Office Action Summary	Application No. 10/593,483	Applicant(s) HASEGAWA, MITSURU	
	Examiner JOSEPH JOHNNIE	Art Unit 4118

DETAILED ACTION

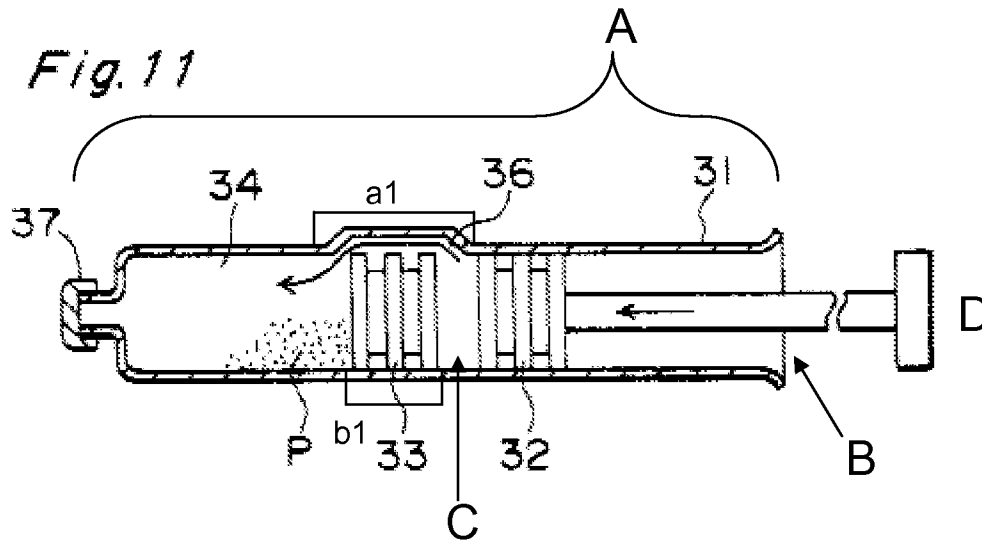
5. In re claim 1, Ohtani discloses a pre-filled syringe comprising: a barrel (element A of figure 11 shown below) having a tip with a nozzle (element 37 of figure 11), an open base end (element B of figure 11 shown below), an intermediate gasket (element 33 of figure 11) liquid-tightly partitioning the inside barrel into a front chamber (element 34 of figure 11) and rear chamber (element C of figure 11 shown below), a sealing plunger gasket located at the base end of the intermediate gasket (element 33 of figure

11), a plunger rod connected to the base, and a bypass protruding outwardly in the radial direction on the tip side of the barrel relative to the intermediate gasket.

6. In re claim 2, Ohtani discloses a syringe where the axial length of the bypass (a1 of figure 11 above) is greater than the axial effective length of the seal (b1 of figure 11 shown above). Refer that $a1 > b1$ in figure 11 shown above.

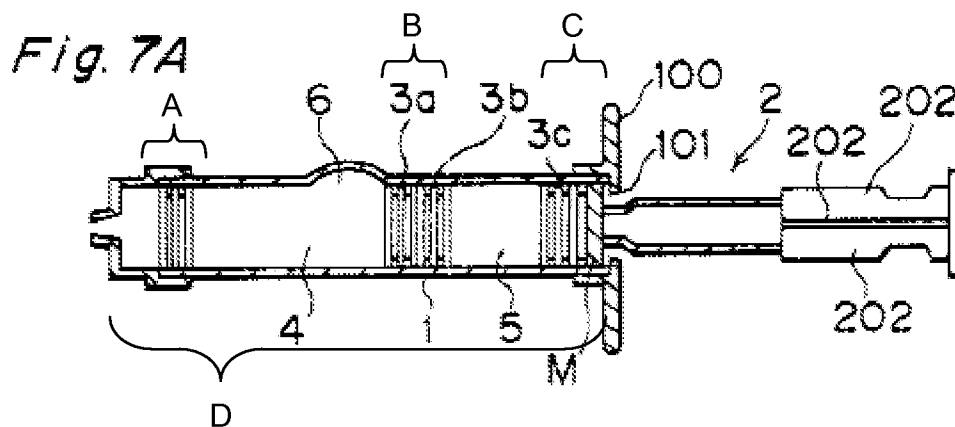
10. In re claim 9, as best understood, Ohtani discloses a pre-filled syringe wherein if axial length of tip gasket is A (element A of figure 7a below), axial length of intermediate gasket is B (element B of figure 7a below), and axial length of plunger gasket is C (element C of figure 7a below), and length from inner wall tip of nozzle to inner wall base end is D (element D of figure 7a below), $A + B + C < D$.

11. In re claim 10, Ohtani discloses a pre-filled syringe including an intermediate gasket (element B of figure 7a above), a plunger gasket (element C of figure 7a above), and a tip gasket (element A of figure 7a above) with a front chamber (element 4 of figure of figure 7a) formed between the tip gasket and intermediate gasket.

F I G . 24 .

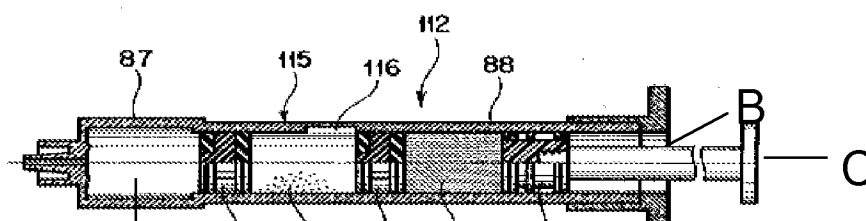
13. In re claim 1, Higashikawa discloses a pre-filled syringe comprising: a barrel (element 88 of figure 24) having a tip with a nozzle (element A of figure 24 shown below), an open base end (element B of figure 24 shown below), an intermediate gasket

(element 91 of figure 24) liquid-tightly partitioning the inside barrel into a front chamber (element 113 of figure 24)and rear chamber (element 114 of figure 24), a sealing plunger gasket located at the base end of the intermediate gasket (element 100 of figure 24), a plunger rod connected to the base (element C of figure 24 shown below) and a bypass (element 116 of figure 24).

14. In re claim 10, Higashikawa discloses a prefilled syringe where in there is a tip gasket (element 90 of figure 24), an intermediate gasket (element 91 of figure 24), an open base end (element B), a base end gasket (element 100 of figure 24), a plunger (element C of figure 24 shown below), a bypass near the intermediate gasket (element 116 of figure 24), a front chamber (element A of figure 24), intermediate chamber (element 116 of figure 24), and end chamber (element 114 of figure 24).

15. In re claim 11, Higashikawa discloses a prefilled syringe where in there is an intermediate gasket (element 91 of figure 24), a base end gasket (element 100 of figure 24), a plunger (element C of figure 24 shown below), a bypass near the intermediate gasket (element 116 of figure 24), a front chamber (element 87 of figure 24), intermediate chamber (element 116 of figure 24), an end chamber (element 114 of figure 24), a tip gasket (element 90 of figure 24), and a tip gasket accommodation (element 87 of figure 24), with the tip including a passage through which medicine can pass when the tip gasket is in the tip gasket accommodation part (element 87 of figure 24).

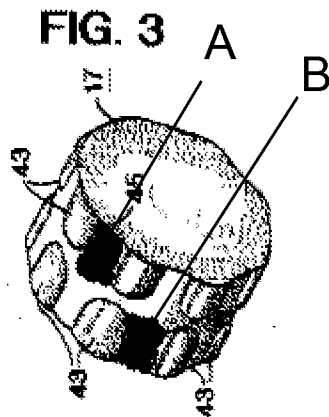
18. In re claim 5, Ohtani discloses all of the claimed invention except for a connection passage on the intermediate gasket which is a spiral shaped groove. Hughes discloses a prefilled syringe including a connection passage which is a spiral groove (element 48 of figures 5 and 6) in the outer wall of the intermediate gasket (element 46 of figure 5). Since the spiral shape is conducive to controlling the flow of a liquid, and the spiral moves around the gasket in a circumferential direction, it would be obvious to modify Ohtani's device to include the grooved spiral connection passage with the bypass in the circumferential direction as taught by Hughes for the purpose of
